ATTACHMENT 1

1) Rationale behind submission

2) Amendments requested

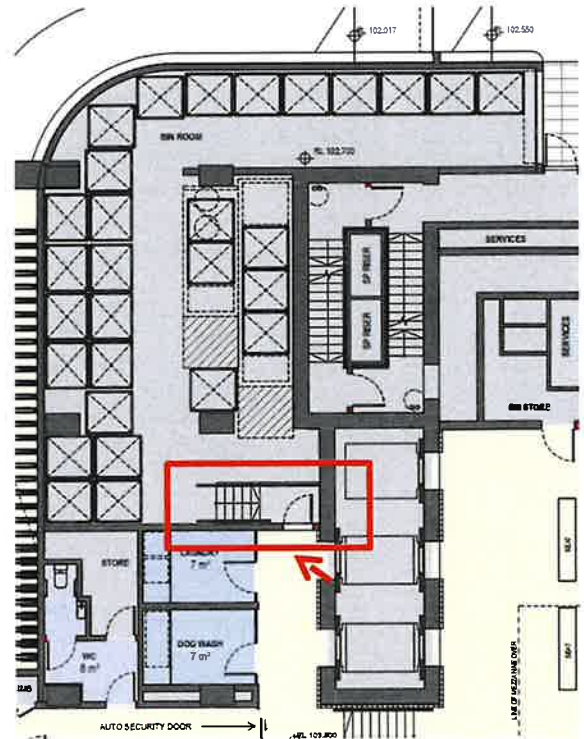
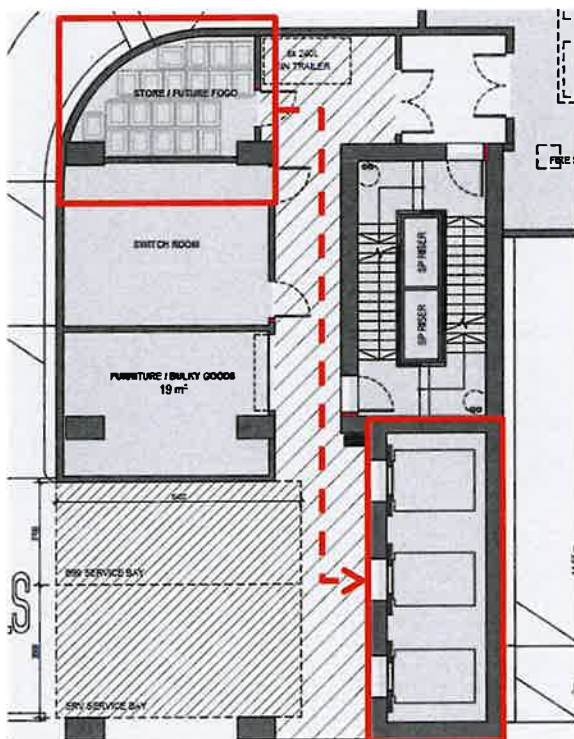
It is acknowledged that the development has begun to consider FOGO waste disposal, which is viewed favourably. However, the current system does not appear to be practical for residents to dispose of food waste. The current proposal, which requires residents to “be responsible for walking their own FOGO down to the communal FOGO bin room” (OWMP, Elephants Foot, Rev C, 20/05/2024, p. 11), is unlikely to work practically. With the convenient disposal for general waste and recycling on each residential level, through waste and recycling chutes, residents are unlikely to travel to the B1 Level FOGO bin room to dispose of food organics. This would lead to food waste disposal in the waste or recycling chutes, leading to the loss of a large proportion of recoverable material and potentially high recycling bin contamination rates. This is not conducive to achieving Council’s improved resource recovery targets and increased diversion of organics waste from landfill (see the *Northern Sydney Regional Waste Strategy 2022* which has been adopted by Council).

It is Council’s preference that there is a FOGO disposal option for residents that is in close proximity to the general waste and recycling disposal options. This would make waste separation and disposal convenient for all residents so they are able to drop-off all waste to one central point. The waste, recycling and FOGO disposal locations for residents (waste chutes or waste storage cupboards on each residential level) should be designed by considering FOGO disposal and bulky cardboard waste disposal, as outlined in the previous point.

The OWMP and architectural plans do not indicate the FOGO bin carting route from the B1 Level to Ground Level. It appears that the caretakers must use residential lifts to cart the bins as there is no back-of-house lift. There also appear to be obstacles (i.e., steps and doors) in the route to cart FOGO bins to the Ground Level bin room for collection or the bins must be carted through the residential lobby. The figures below highlight these issues.
